<b>Derby Diocesan Association of Church Bellringers Consultant's Report</b>	<b>Report DDACB 0806</b>
<b>Church of St Giles at Great Longstone Comments on Bell Improvement Proposal</b>	<b>Issue Date 18/12/06</b>

Church Warden Mr Mike Hirst requested the opinion of DDA Bell Consultants Robin Lyon and Mike Banks on a local proposal to improve the bell installation at St Giles Church Great Longstone. This report sets out the views and recommendations of the Bell Consultants following their inspection on 7th December 2006.

FIGURE 1 EXISTING RINGING CIRCLE

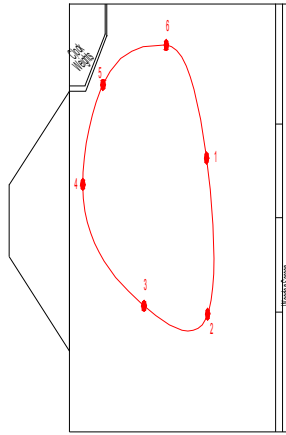
Figure 1 shows the shape of the existing rope circle and illustrates the deficiencies needing correction.

- As already noted, ropes 4 and 5 are too close to the tower walls.
- Ropes 2,3 and 4 almost lie in a straight line.

FIGURE 2 PROPOSED RINGING CIRCLE

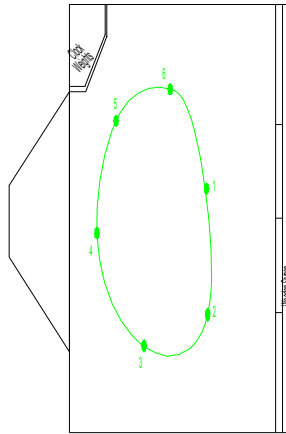
Figure 2 shows the proposed optimised rope circle and it can be seen that the new circle is much improved, being more nearly round and with the ropes more evenly spaced. Also free space around each rope is considerably improved giving the following approximate radial clearances:

Rope	Approximate Clear Radial Space Around Rope (mm)
1	>600
2	600
3	450
4	400
5	400
6	450

Given the small cross section of the tower these clearances are acceptable and will enable training of new ringers to be performed in much greater safety.

FIGURE 3  
CLOCK ROOM LAYOUT

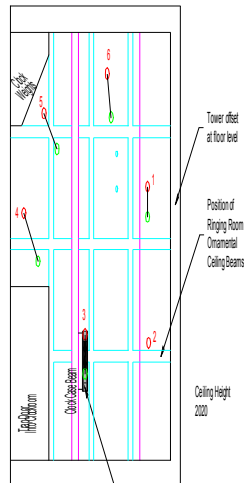
The internal dimensions of the tower were measured in the ringing room and clock room. Also the position of each rope was established by measuring its co-ordinates in relation to two datum walls in the ringing room. Since the ropes fall vertically, these positions could also be translated to the points at which the ropes pass through the clock room floor. Figure 3 shows a plan view of the clock room with the underlying beam positions shown in blue (taken from the proposal). The red circles show the existing rope penetrations of the floor and the green circles show the proposed new positions.

The proposed use of additional pulleys to bring about these rope offsets appears to be acceptable, but with one proviso. In the proposal, offset of rope 3 is achieved by means of a pulley built around the right hand winding shaft of the clock. As stated in section 2.0 the clock must not be compromised and so the pulley box should be attached to the inside of the clock case at the position shown in figure 3. Care should be taken to keep the rope, rope channel and pulley box outside the swept volume of the clock-winding key. A corresponding ceiling pulley will have to be fitted to the clock case roof.

It is probable that drawing of rope 5 will interfere with the opening of the existing clock case door. This will require further thought.
